November 16, 2012
RC-12-0179

Subject: VIRGIL C. SUMMER NUCLEAR STATION (VCSNS) UNIT 1
DOCKET NO. 50-395
OPERATING LICENSE NO. NPF-12
RELIEF REQUEST RR-III-09 REQUEST FOR INFORMATION
FATIGUE CRACK GROWTH AND TRANSIENTS

VIRGIL C. SUMMER NUCLEAR STATION UNIT 1
REQUEST FOR ADDITIONAL INFORMATION
Relief Request RR-III-09
Alternative Weld Repair For Reactor Vessel Head Penetration
Fatigue Crack Growth

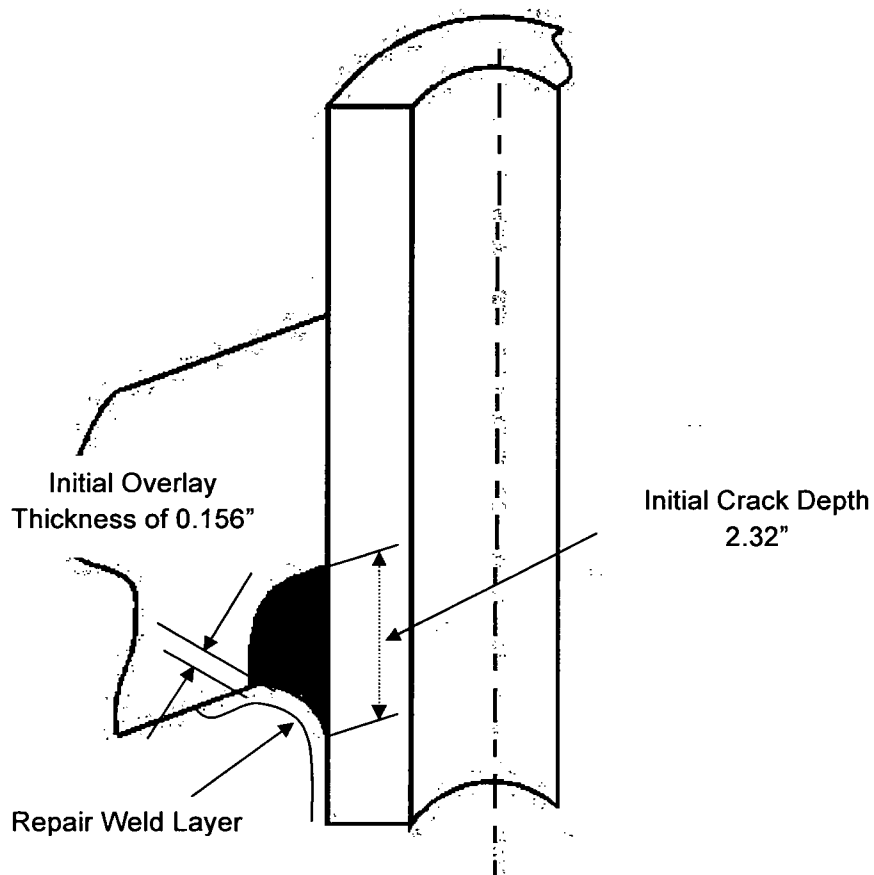
Please provide a sketch of the head cross section / J-groove weld / nozzle tube / weld overlay showing the dimensions of the flaw assumed in the present analysis (LTR-PAFM-12-137-NP Rev. 2).

Note: The remaining overlay thickness is 0.142" after 20 years of fatigue crack growth
